"PRELIMINARY OVERALL AREA DEVELOPMENT PLAN"

CANYON CREEK BLUFFS SUBDIVISION
A PLANNED UNIT DEVELOPMENT

Re: Canyon Creek Bluffs PUD /POADP # 341

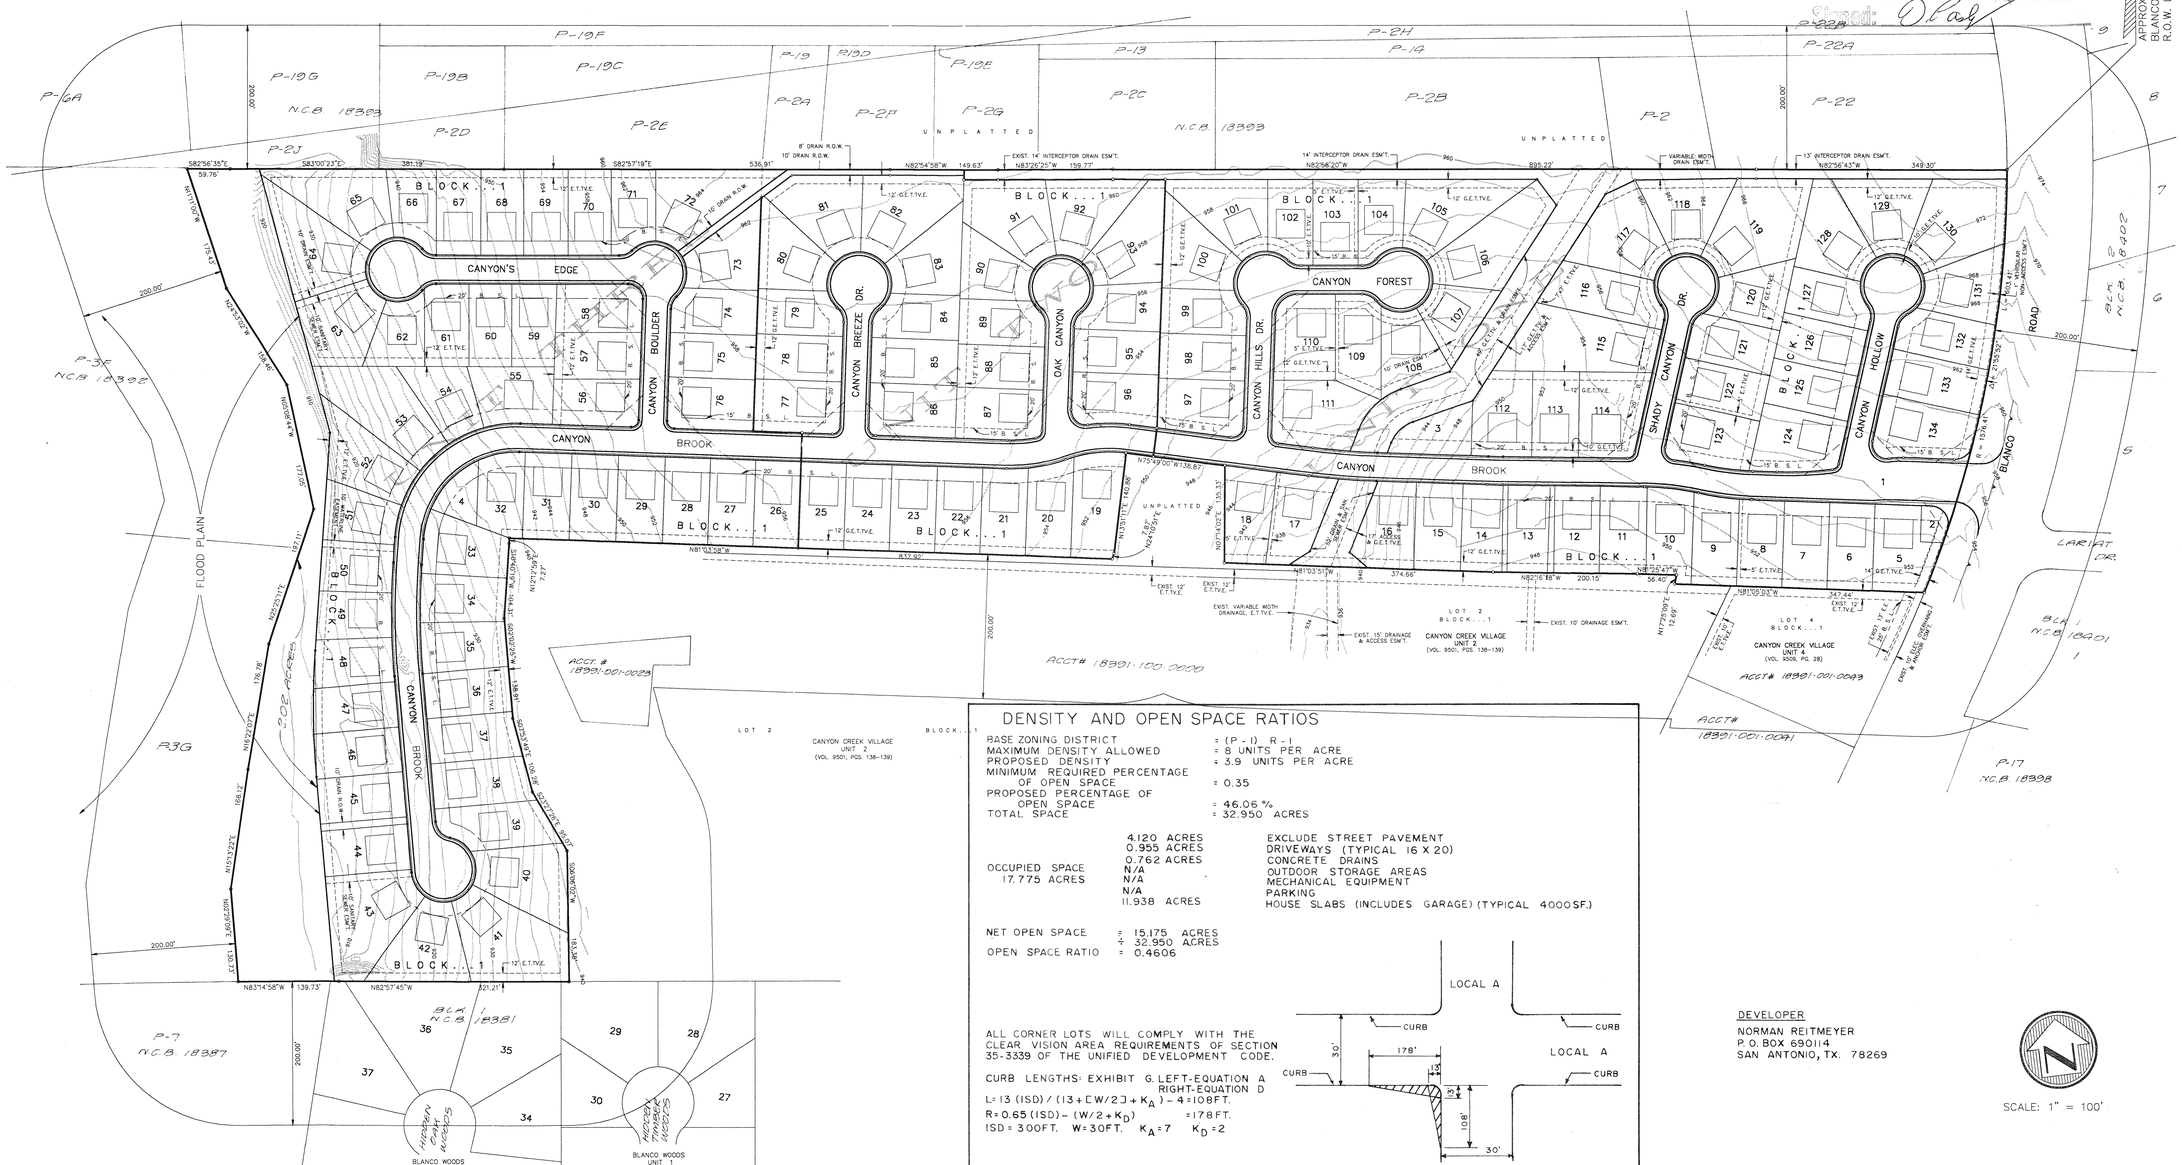
The Development Review Committee has reviewed and accepted the captioned Preliminary Overall Area Development Plan. The plan as submitted is in general conformance with the Unified Development Code with the exception of the proposed street offset at Canyon Brook and Lariat Dr. Street jogs with center line offsets of less than 125 feet are not permitted. This will involve a request for variance, or redesign of the intersection will be necessary. Additionally, acceptance of cul-de-sac streets in excess of 500 will require written justification in conjunction with the plat review process. Also for traffic engineering review, please submit a detailed section reflecting the location of planned access control.
